Re: Town of Sherborn – Sherborn Library Project  
December 28, 2016 Construction Contract (Five Star Building Corporation)  
June 15, 2020 Takeover Agreement (Travelers Casualty and Surety Co. of America)  
Performance Bond No. 007-SB-106605907 (Travelers Casualty and Surety Co. of America)  
Notice of Unfair/Deceptive Acts/Practices and Demand for Relief – G.L. c. 93A, § 9

## ARCHITECT'S FIELD REPORT

| <b>PROJECT:</b> SHERBORN LIBRARY Renovations & Addition  | <b>FIELD REPORT NO:</b> 49  |

Line 1 CW F-G: (+/-)1/4" max exist joint

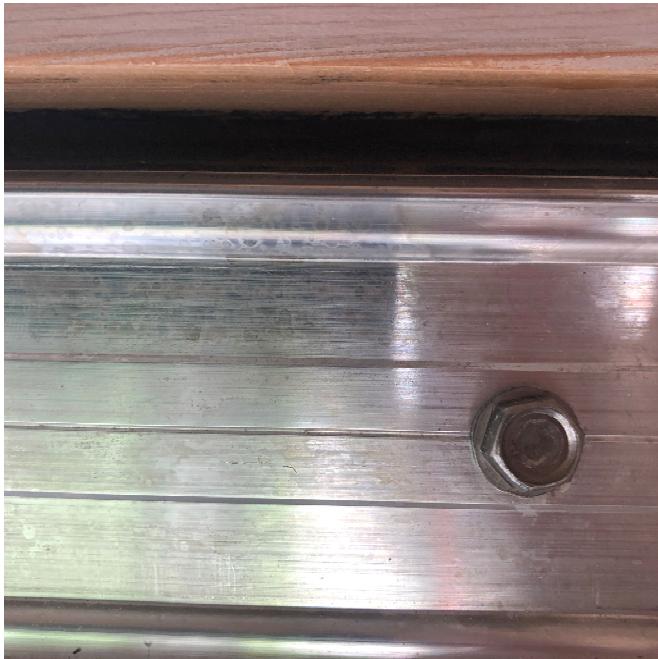
- BCG/Debrino/FSBC determined that the snap on cover could not be removed to install the primary sealant at First Floor CW Bay H-J and K-L because the joint does not exist at these heads for the proper installation of a backer rod & sealant.

- The cedar board of the horizontal soffit butts to the top face of the aluminum curtainwall frame @ the north side jamb of CW Bay H-J and the cedar board butts +/- 1/4" below the top of the aluminum curtainwall frame at the south side jamb.

Line 1 CW F-G: Primary sealant cannot be installed - exist joint @ (+/-) 1/4" to 0"

Line 1 CW H-J: Snap on cover cannot be removed. 1. The cedar board of the horizontal soffit butts to the top face of the aluminum curtainwall frame @ the north side jamb. 2. The cedar board butts +/- 1/4" below the top of the aluminum curtainwall frame at the far south side jamb. 3. There is no head joint/reveal for the primary sealant. The cedar board butts directly to aluminum curtainwall frame and the sealant/residue is only left on the aluminum curtainwall frame.

- 1) BAA to provide existing/as-built drawings of built head conditions at (5) curtainwall head assembly and associated soffit and/or bulkhead layouts/configurations for confirmation by the GC/Subcontractors.

- 2) BAA to provide remedial curtainwall head details and program for corrective work required at (5) curtainwall head assembly and associated soffit and/or bulkhead layouts/configurations for review with the GC/Subcontractors for compliance.

1  
ASK-108D

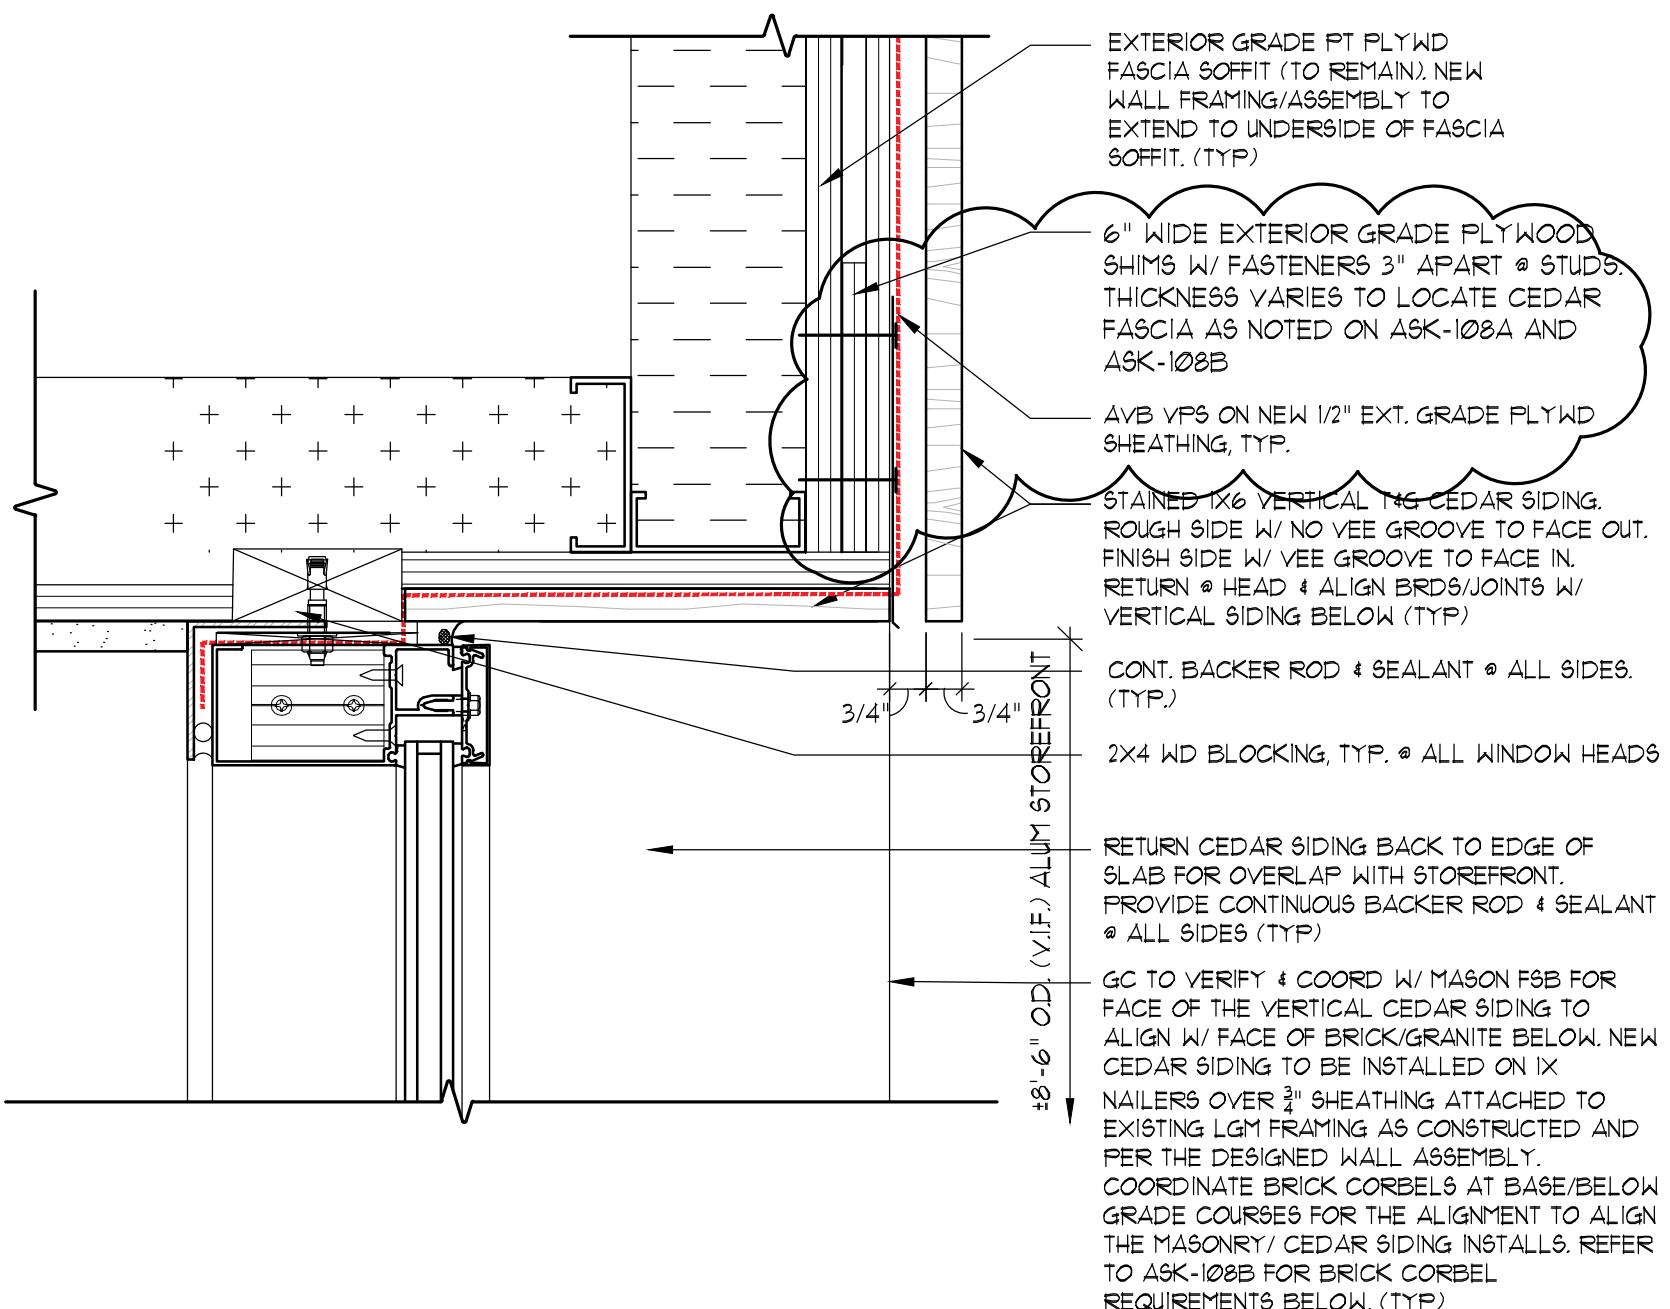
- BAA reviewed with BCG/Debrino/FSBC ASK-108-BR1 & ASK-108-DR1 dated 6/15/2021 for the typical curtainwall head configuration detail along the 1-Line horizontal cedar board soffit, indicating the head joint with continuous perimeter backer rod & primary sealant to be installed. As reviewed and observed, the curtainwall head assemblies and soffit layouts/configurations do not conform to the design documents. See ASK-108-BR1 & ASK-108-DR1 dated 6/15/2021.

CLOUDED AREAS SHOW CORRECTIVE WORK TO ADDRESS MISALIGNMENT OF THE BUILDING ADDITION
